Collective amendments to UN Regulations Nos. 16, 94, and 137

Submitted by the expert from OICA

I. Proposal for the 08 series of amendments to UN R16

Model A
(See paragraph 5.2.4. of this Regulation)

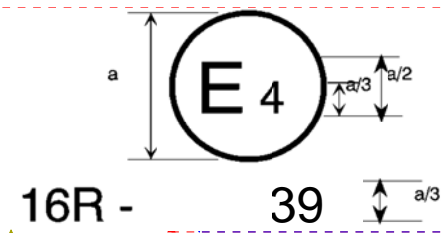
The above approval mark affixed to a vehicle shows that the vehicle type concerned has, with regard to safety-belts, been approved in the Netherlands (E4) pursuant to Regulation No. 16. The approval number indicates that the approval was granted according to the requirements of Regulation No. 16 as amended by the 08 series of amendments.

Model B
(See paragraph 5.2.5. of this Regulation)

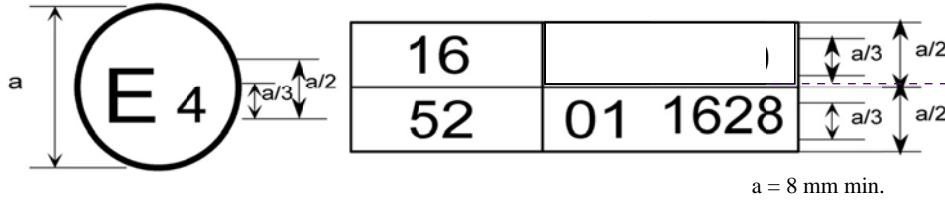
The above approval mark affixed to a vehicle shows that the vehicle type concerned has been approved in the Netherlands (E4) pursuant to Regulations Nos. 16 and 52¹. The approval numbers indicate that, at the dates when the respective approvals were given, Regulation No. 16 included the 08 series of amendments and Regulation No. 52 the 01 series of amendments.

2. Arrangements of the safety-belt approval marks (See paragraph 5.3.5. of this Regulation)

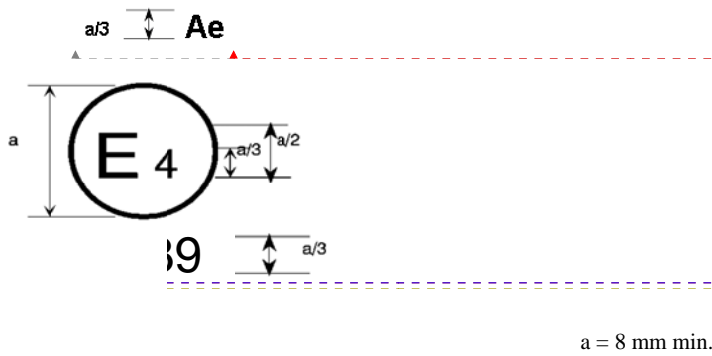
The belt bearing the above approval mark is a three-point belt ("A"), fitted with an energy absorber ("e") and approved in the Netherlands (E4) under the number 082439, the Regulation already incorporating the 08 series of amendments at the time of approval.

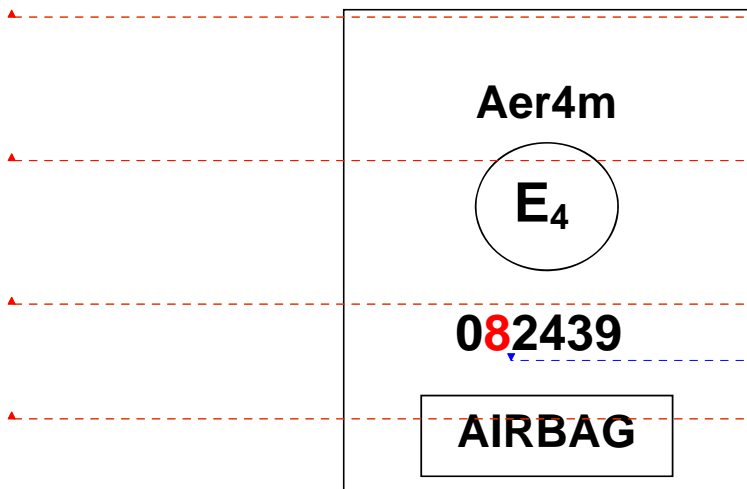
The safety-belt bearing this type-approval mark is a three-point belt ("A") fitted with an energy absorber ("e"), approved as meeting the specific requirements of paragraph 6.4.1.3.3. of this Regulation, and with a multiple-sensitivity ("m") type 4 ("r4") retractor, in respect of which type approval was granted in the Netherlands ("E4") under the approval number 082439. The first two digits indicate that the Regulation already incorporated the 08 series of amendments at the time of the approval. This safety-belt has to be fitted to a vehicle equipped with an airbag in the given seating position."
